SEPTEMBER 10, 2026

PRODUCT UPDATE
DRIVE GEAR CHANGE

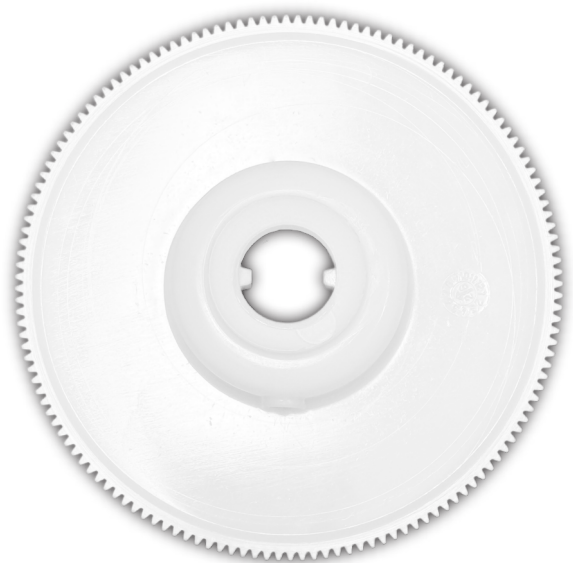
The drive gear for the WS2HF, WS3, 3" MAV, and 3" NHWB Drive Cap assemblies will no longer have 4 holes. This will be a rolling change as inventory is consumed.

The holes in the drive gear allowed access to the screws on the old Poppet Valve Drive Cap that has been discontinued since 2009.

CURRENT

FOUR HOLES IN GEAR

NEW

NO HOLES IN GEAR
